**Subject: Response to Portion of NRC Request for Additional Information
Letter No. 43 Related to ESBWR Design Certification Application –
ESBWR Containment Design and Probabilistic Risk Assessment Re:
Containment Fragility Analysis – (Release A) RAI Numbers 6.2-95,
6.2-97, 19.2-41, 19.2-44 to 19.2-46, 19.2-49, 19.2-50 and 19.2-57**

1. MFN 06-268 – Partial Response to NRC RAIs 6.2 and 19.2 Release A RAI 6.2-95, -97, 19.2-41, -44, -45, -46, -49, -50 and -57
2. MFN 06-268 – DCD Section 6.2 and NEDO 33201 Table B.8-1 Markup Pages for RAIs 6.2-95, & -97, and RAI 19.2-45c

**Partial Response to NRC RAIs 6.2 and 19.2 Release A
RAI 6.2-95, -97. 19.2-41, -44,-45, -46, -49, -50 and -57**

Figure 6.2-95(1). Nodal Locations

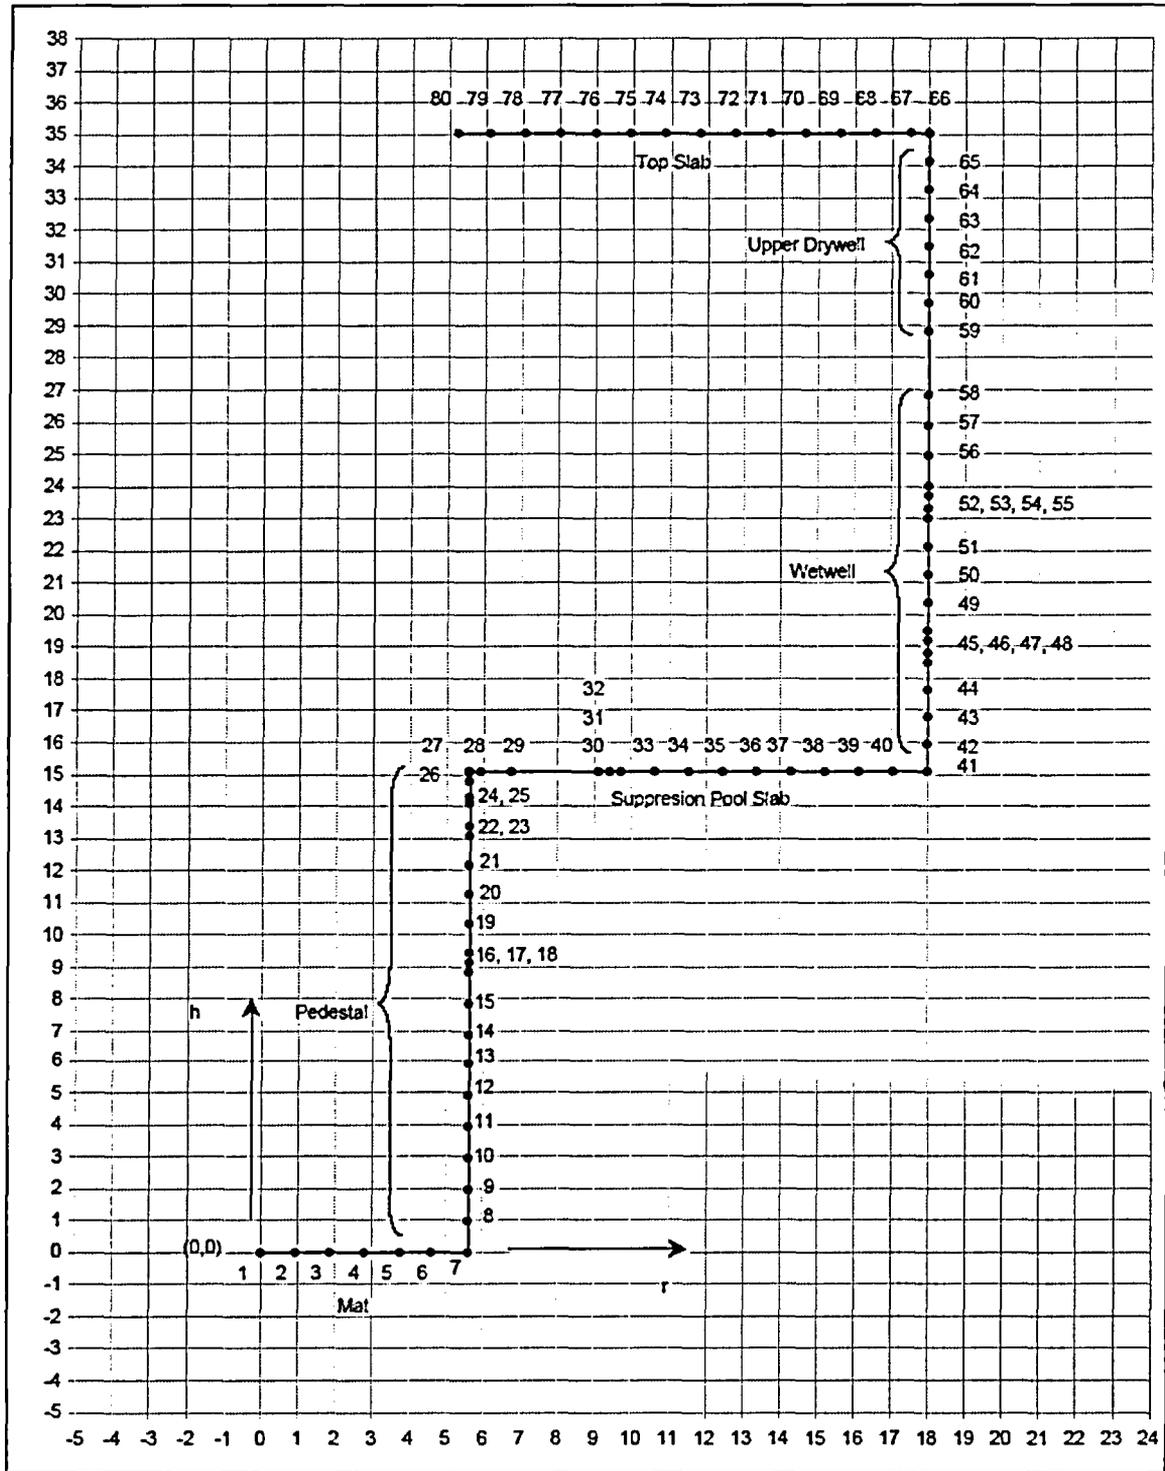
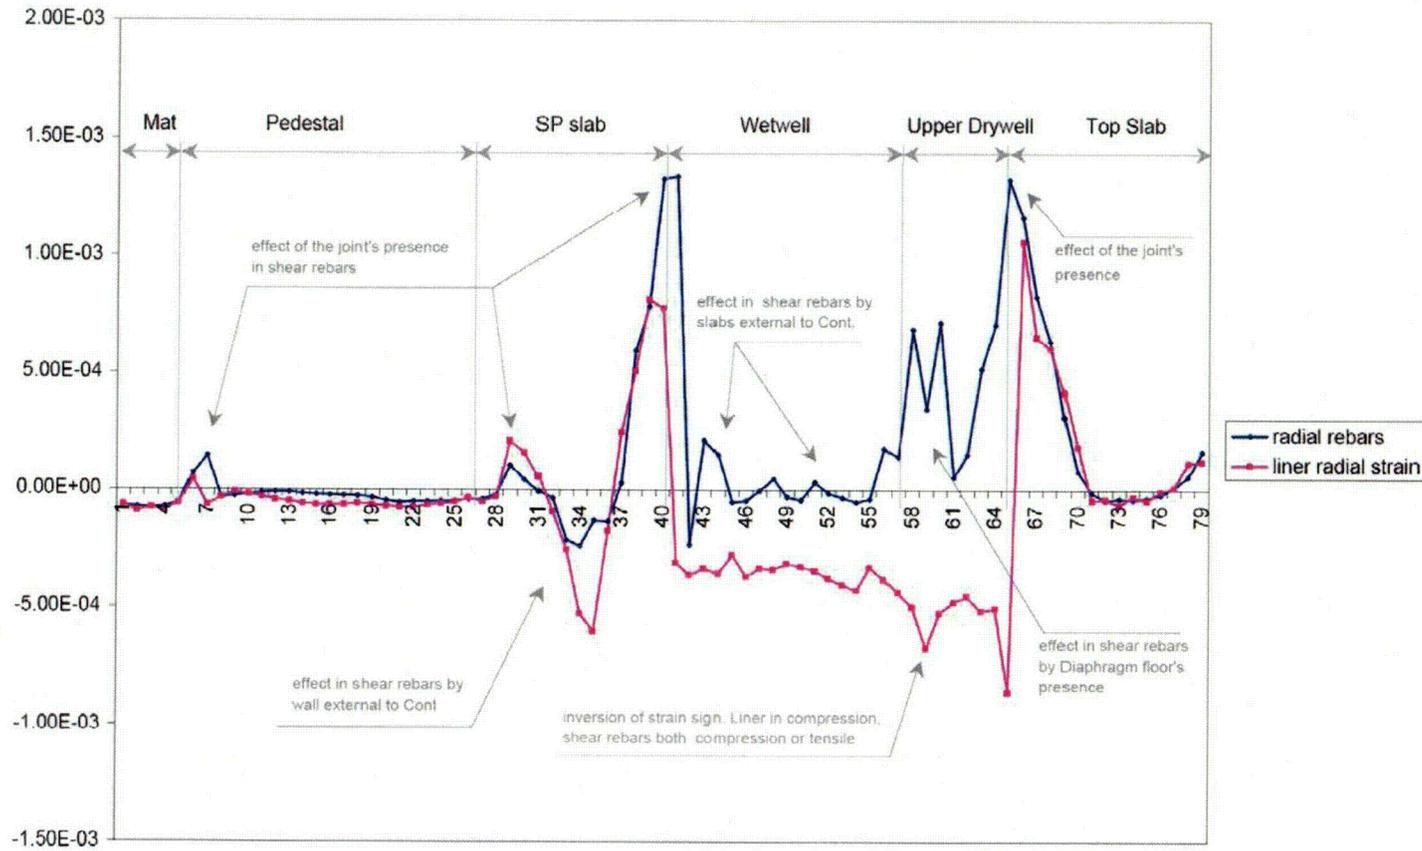
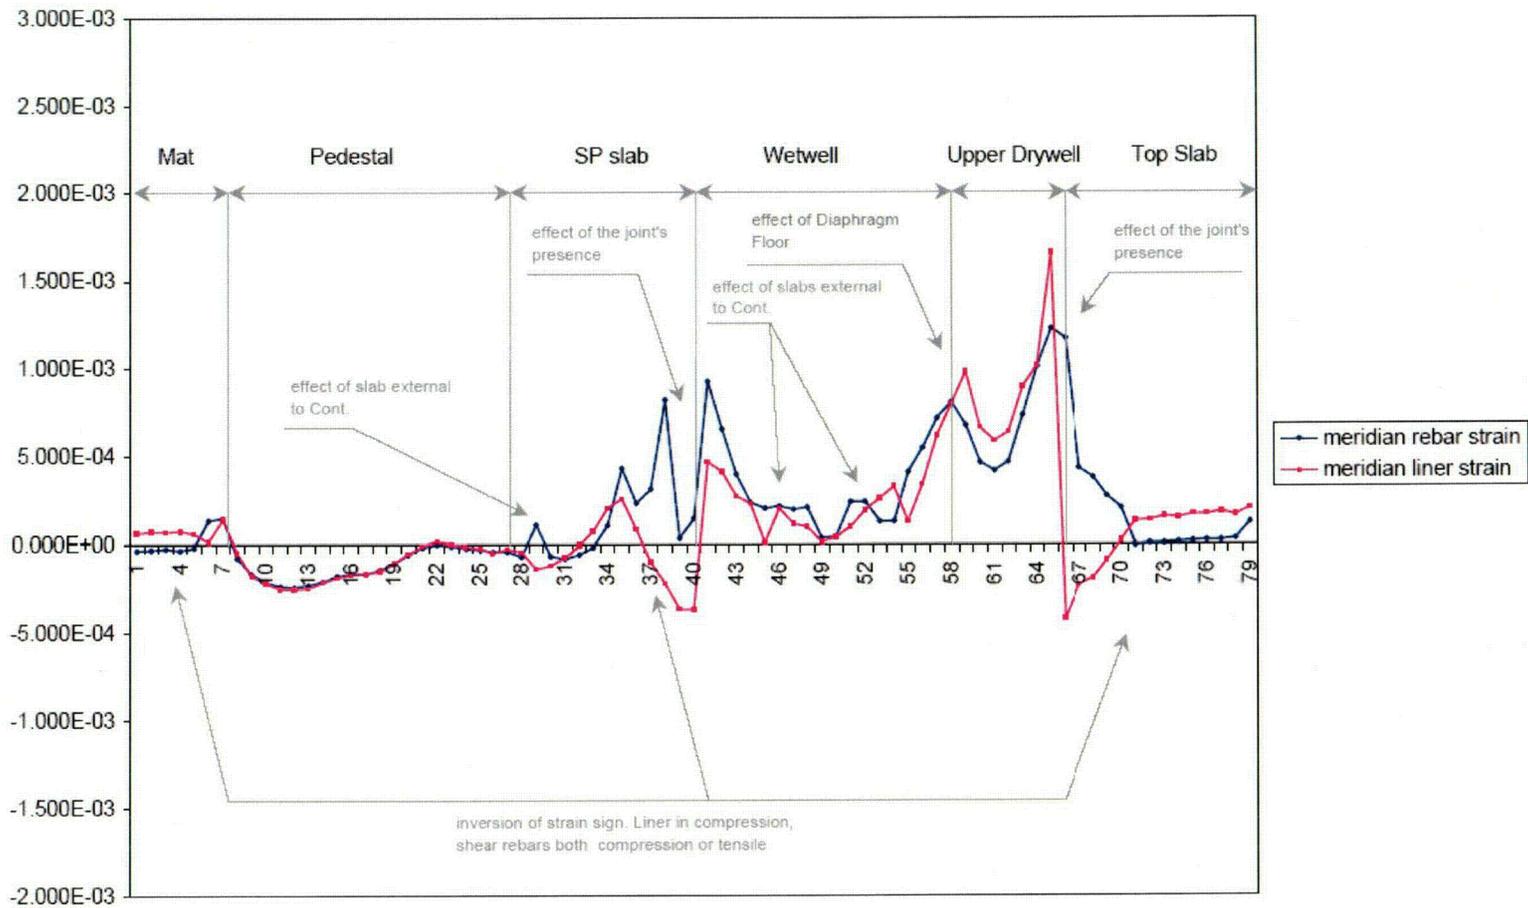
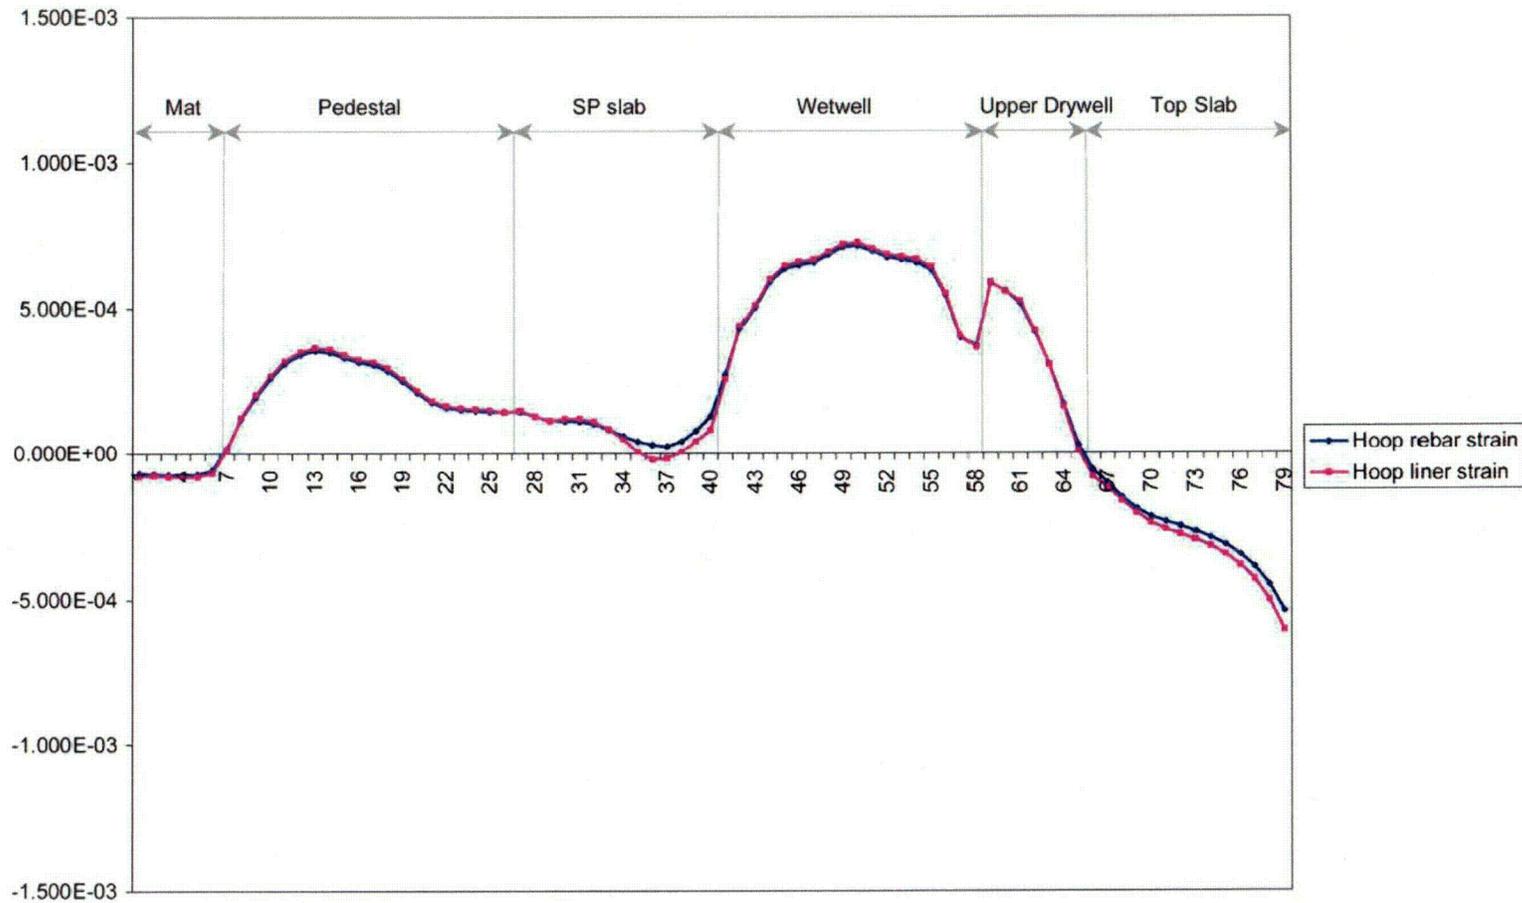
- a) Comparison of the concrete and rebar stresses to their factored load allowables.*
- b) Of the liner, concrete, and rebar, which limits the Level C pressure capability of the concrete containment (ignoring the steel penetrations)?*
- c) Compare the rebar strains to the liner strains at the 1.468 MPa load level. Explain any significant differences between the two.*
- d) The spacing between the anchors for the liner plate, including drawings to show how the liner is anchored into the concrete.*
- e) Locations (typical) of the heat affected zone at the liner weld seams and the proximity to liner anchors.*

- c) Figures 6.2-95(2), (3) and (4) show a comparison of the liner strains and rebar strains for concrete elements in contact with the liner in the radial, meridian and hoop directions, respectively, along the nodes shown in Figure 6.2-95(1). There are no significant differences between them if the rebars belong to a plane parallel to that of the liner. The comparison of the vertical shear rebar strains to the vertical liner strains (mat, SP slab or Top Slab), as well as of the radial shear rebar strains to the radial liner strains (Pedestal, Wetwell or Drywell) shows some differences. The explanation lies in how the load is being resisted, mainly, by bending and shear of

those structural elements. The shear stress distribution in shear rebars is therefore slightly different from that of the liner

Accordingly, the liner is mostly compressed in those areas, whereas the rebars can be under tensile or compression stress.

Other effects such as the proximity to the joint between structural members, as well as the presence of slabs, cause additional local differences. Note that, in spite of the differences, all rebar and liner strains are of the same order.

As for the hoop strain comparison, since none of the previous factors are present, liner and rebar deform in a consistent manner, such that there are not significant differences between them.

Figure Att. 19.2-44(4) Comparison ANSYS results vs McNeice results (dashed and blue) at center point

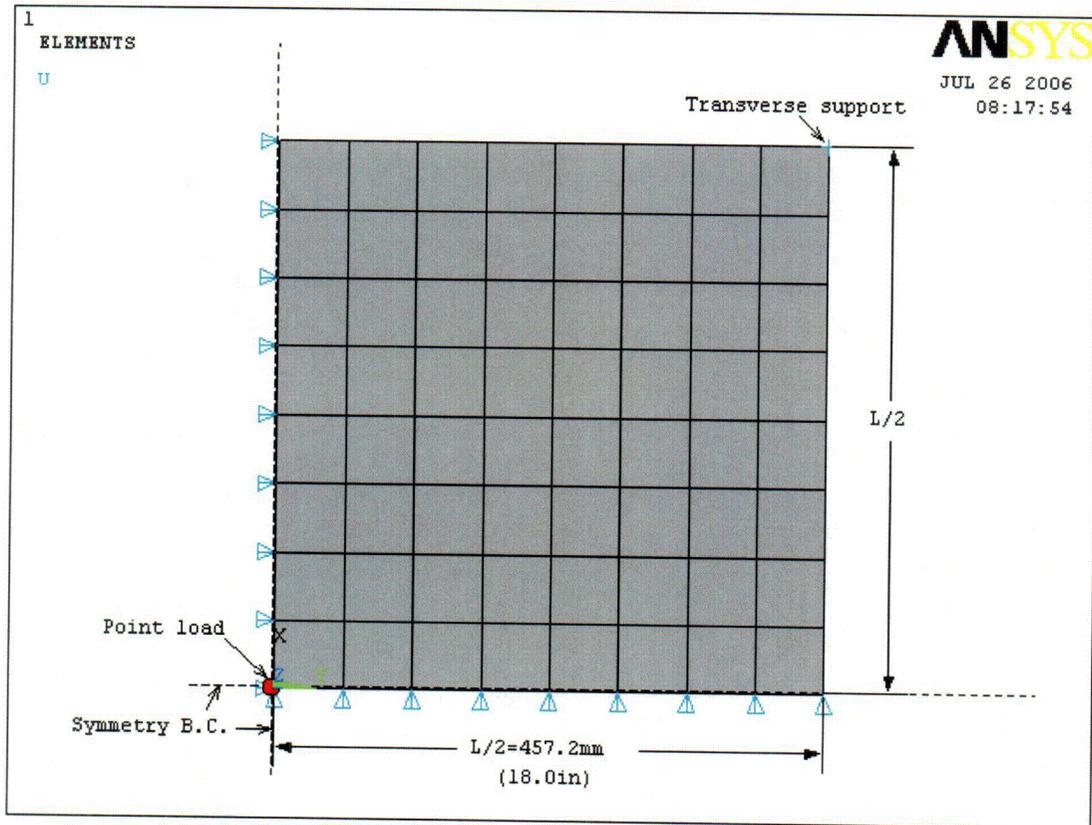
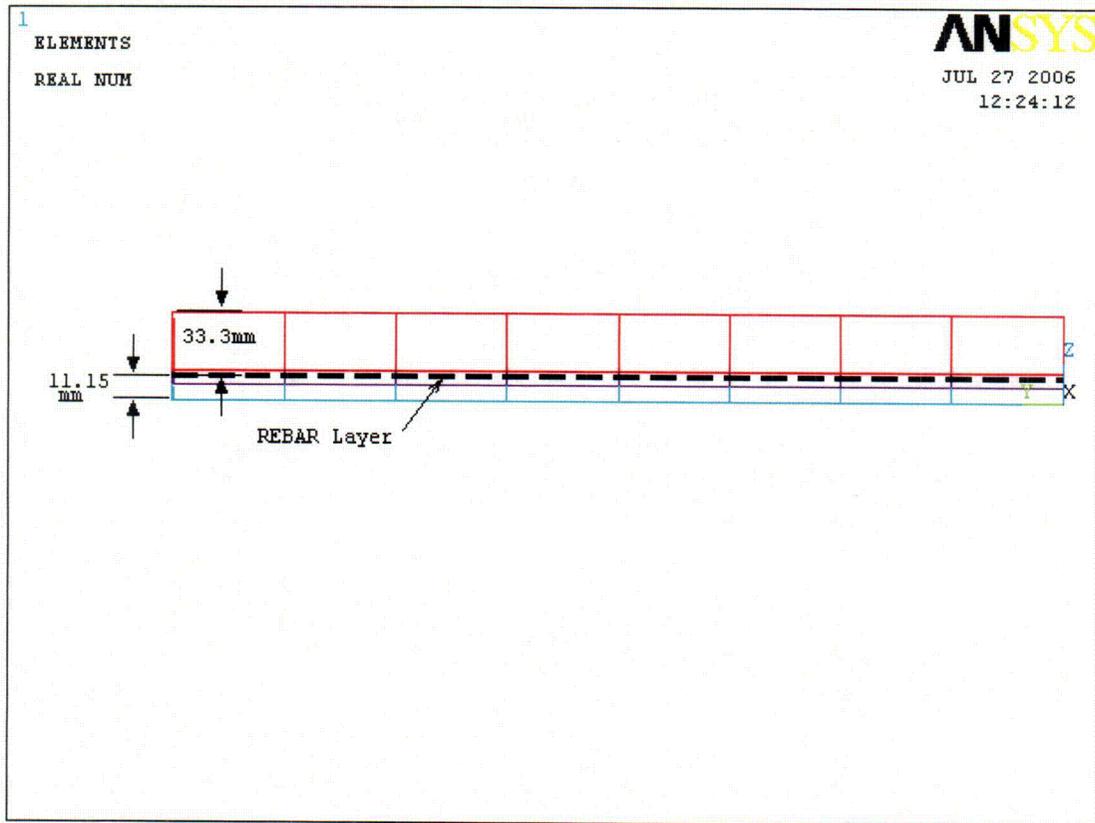
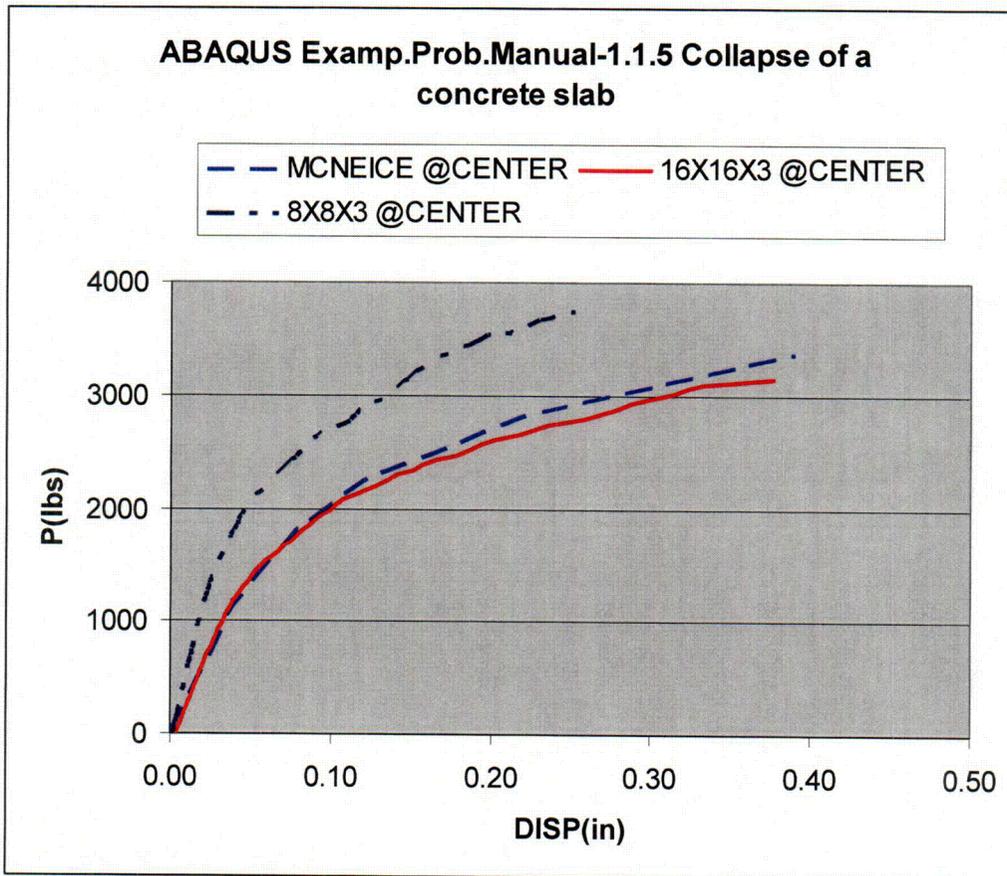
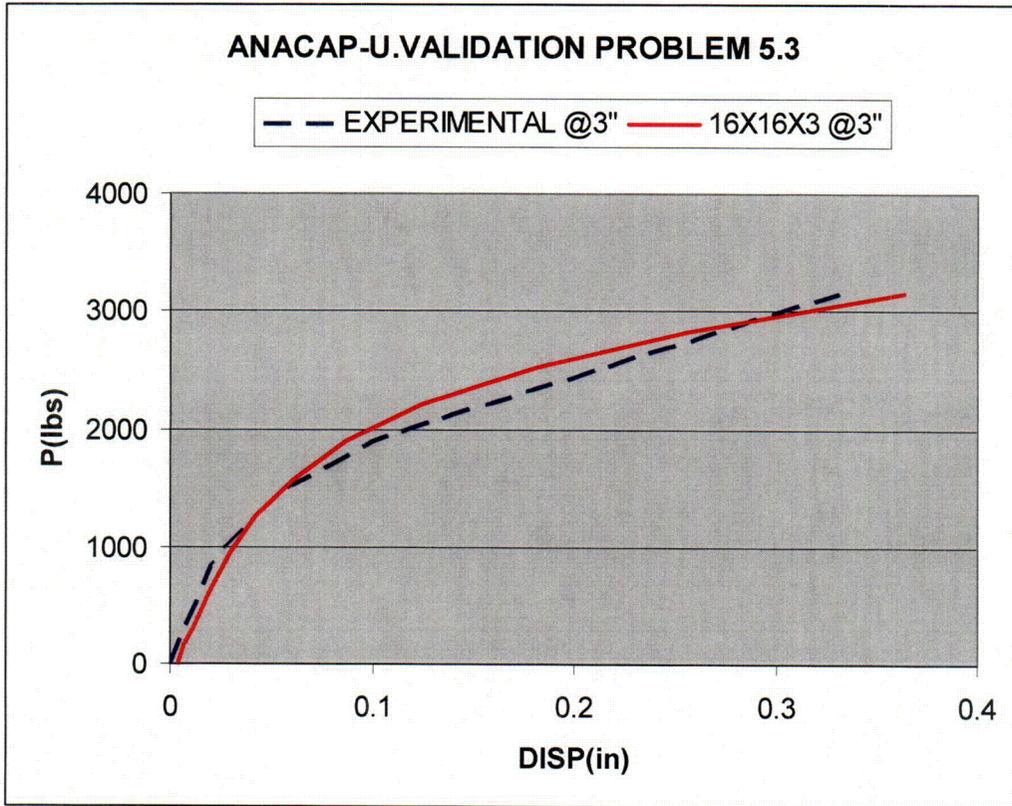
- c) the validation of the ANSYS reinforced concrete material model against other known commercial codes, such as ANACAP or ABAQUS, etc., on similar structures and loading, and their analysis comparisons;*

- c) A comparison between the ANSYS and ABAQUS computer programs for nonlinear calculations involving reinforced concrete is addressed in the attachment to this RAI.

Figure Att.19.2-44(4) shows the load-deflection curve at the centre of the McNeice slab and the ANSYS results for both 8x8x3 and 16x16x3 mesh models. A very good agreement is reached with the 16x16x3 mesh. The 8x8x3 mesh over-predicts the stiffness of the test model.

Figure Att. 19.2-44(5) shows the load-deflection curve at a 3" offset along symmetry axe from origin of the McNeice slab and the ANSYS results for 16x16x3 mesh model. Also a very good agreement is observed.
